AMEREN ILLINOIS COMPANY

2025 BUSINESS PROGRAM IMPACT EVALUATION REPORT

APPENDIX D: CUSTOM INITIATIVE PROJECT REPORTS

Figure 4. Gymnasium Space Asset Area Model

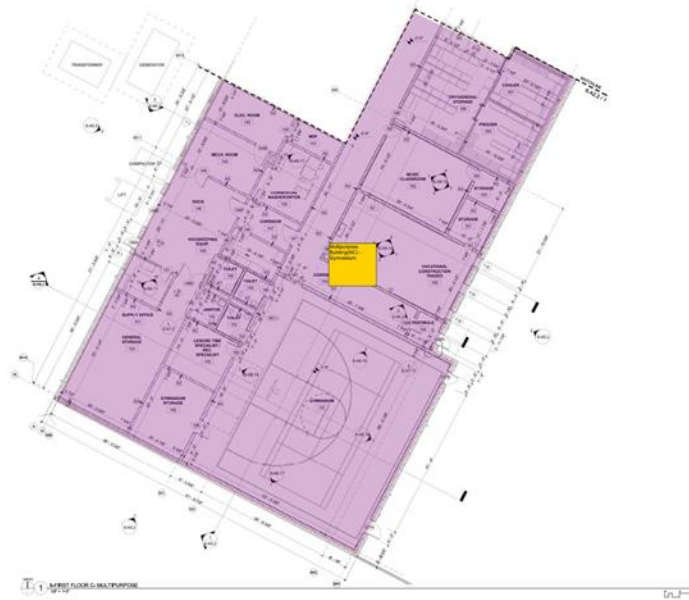
Notable area deviation, Multipurpose Building (NC) Gymnasium is reported as 9,755 s.f. But the area take-off was approximately 4,200 s.f. Please clarify the Gymnasium boundary as it relates to the lighting calculations.

The Multipurpose Building (NC) - Gymnasium Space Asset Area (SAA) in the model represented more than just the Gymnasium space. A Building Type definition is used when defining area in the model. This SAA was larger than just the Gymnasium as it included the classroom, corridor, storage, restroom, and mechanical/electrical spaces in this wing of the project.

Figure 6. Savings versus Baseline

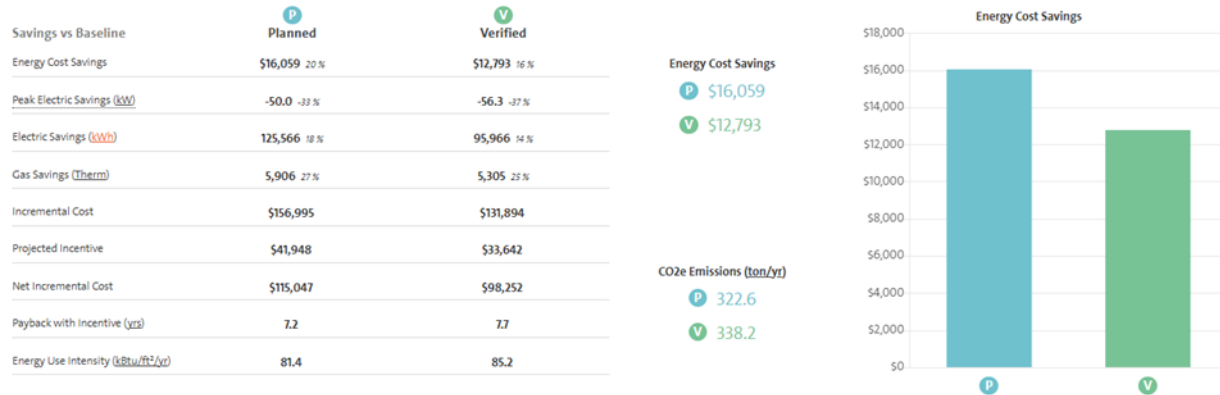
- How does NEO treat interactive effects within various ECM runs, e.g., are the lighting saving measures run before chiller efficiency measures, or does each measure standalone vs. the baseline?
- Notable area deviation – The multipurpose building (NC) gymnasium is reported to be 9,755 sqft. However, the area take-off shows approximately 4,200 sqft. Please clarify the gymnasium boundary as it relates to the lighting calculations.

Each strategy is run in isolation, and results shown in NEO are compared to the Proposed model (PRONS -proposed system at code minimums and no strategies). Results represent a change in the key parameter for the respective strategy. As each strategy is a whole building model simulation, any interactive effects from the measure are accounted for. Lighting strategy results are thus independent of mechanical (chiller) strategy results.

The overall bundle results are compared to the baseline system at code minimum. These results account for all interactive effects of all included strategies within the whole building simulation. Bundle results would account for combined effects of improved lighting power and improved chiller efficiency, as well as all other included strategies.

Figure 10. Sample CFM vs kW Correlation

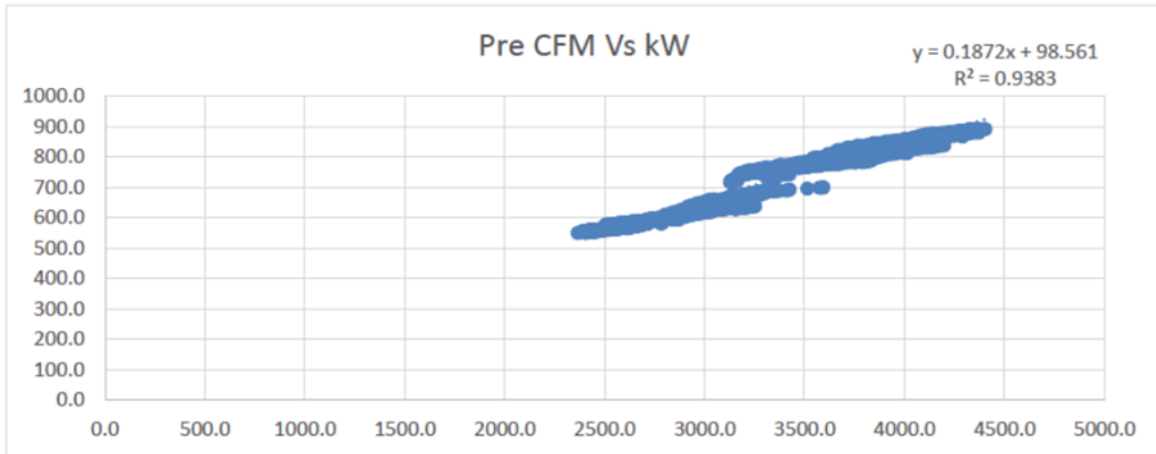
- The evaluation team recommends collecting operating data to establish a correlation between total system compressor power and air production. We suggest collecting pre- and post-implementation data from the vendor in CSV format to make analysis easier. A sample correlation is shown in Figure 1. If strong correlations can be established for pre- and post-operation, they can be used with typical operating CFM to determine baseline and new system demand power kW and energy usage kWh. This will also allow for determining power savings during peak demand periods. Typical operation should be confirmed by the customer, as it could be pre-implementation or post-implementation, or an average of the two conditions.

- . Customer was unwilling to incur the cost of a full-system study. Implementation team used available past study data as possible to validate TRM savings approach.
